POLICY REPORT

Report Date: July 9, 2019
Contact: Karen Hoesse
Contact No.: 604.871.6403
RTS No.: 13303
VanRIMS No.: 08-2000-20
Meeting Date: July 23, 2019

TO: Vancouver City Council
FROM: General Manager of Planning, Urban Design and Sustainability
SUBJECT: CD-1 Rezoning: 485 West 35th Avenue

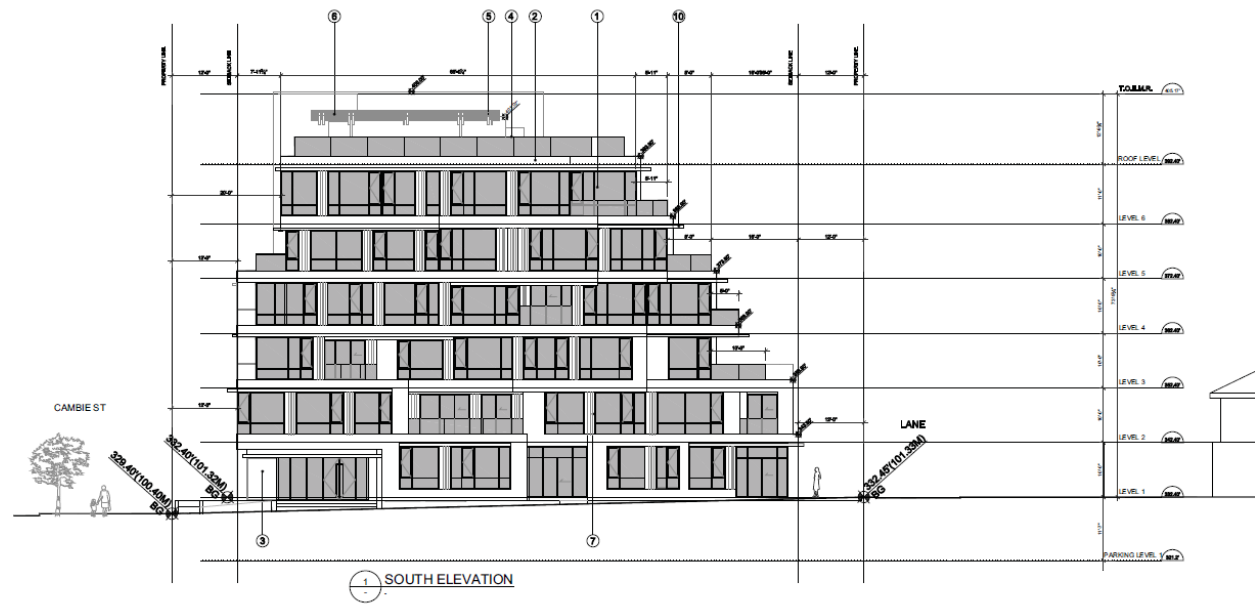
Ms. Brudar noted that the vertical wall of the elevator is a strong grounding element.

Ms. Brudar noted that the entire West 35th Avenue frontage is an elongated public realm and plaza, widening in the area where the tree is located and there is a front and back balance.
